McClellan Nuclear Radiation Center

Reference: University of California, Davis, McClellan Nuclear Radiation Center (UCD/MNRC),
Docket No. 50-607, Facility Operating License No. R-130

A. Proposed New Technical Specifications

DOCUMENT NUMBER: MNRC-0004-DOC-11

UCD/MNRC ORGANIZATION FOR LICENSING AND OPERATION
FIGURE 6.1

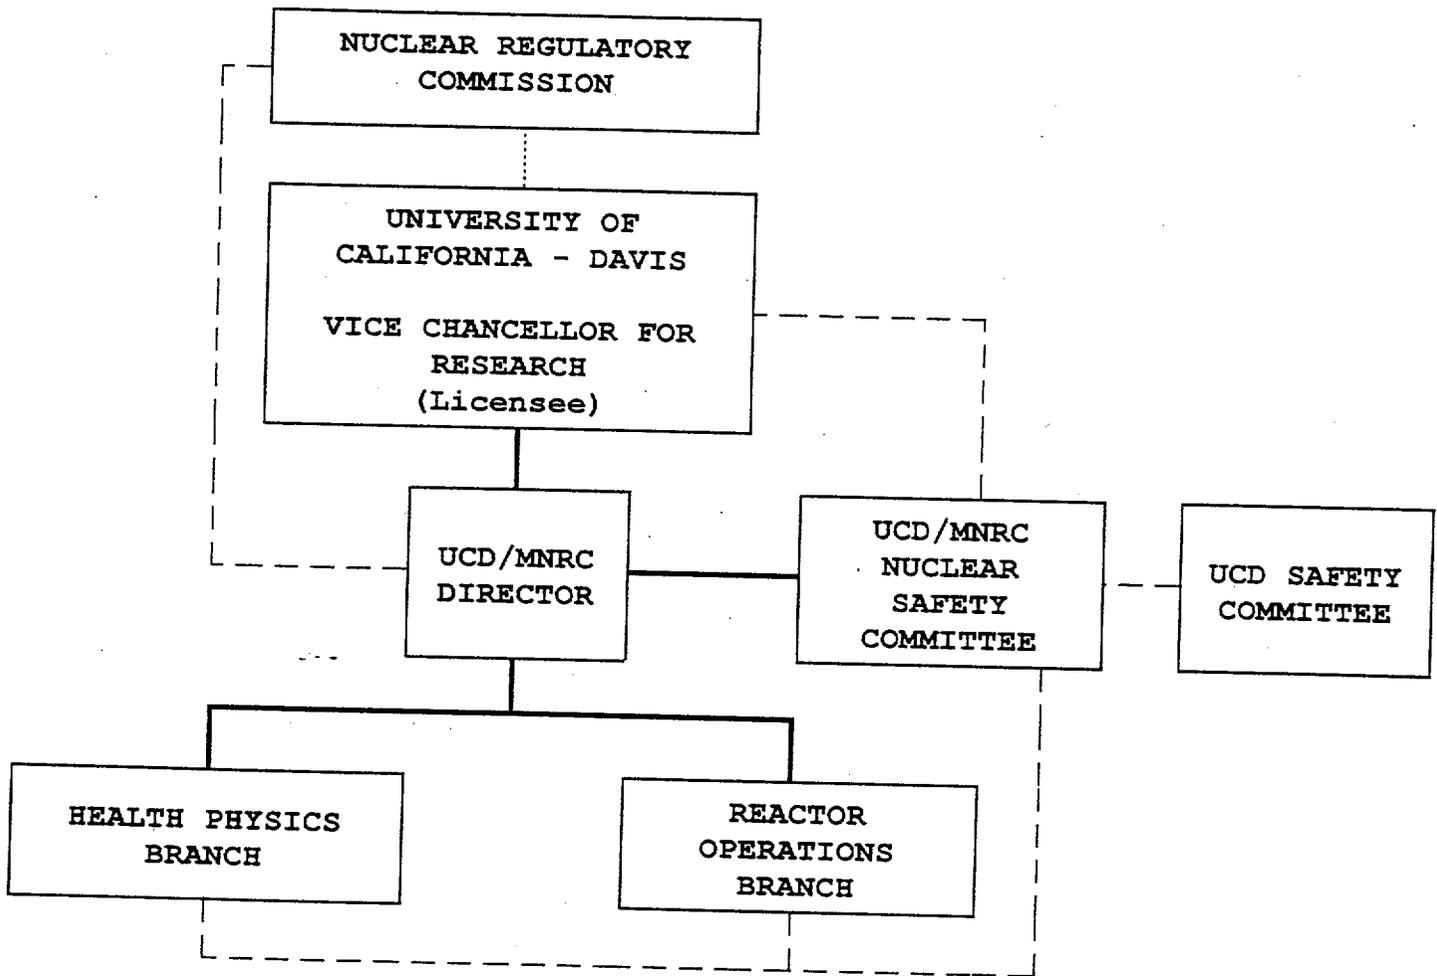
5. Section 6.0: This section has numerous text changes to reflect the new licensee. In addition, there is a new Figure 6.1, Organization for Licensing and Operation, which incorporates administrative units of the new licensee. Section 6.2 has been changed slightly to reflect the organization and duties of the Nuclear Safety Committee (NSC), and to clarify the Committee's review and audit functions. Subsection 6.6.2 was changed slightly to clarify the NSC's role in the event of a reportable occurrence.
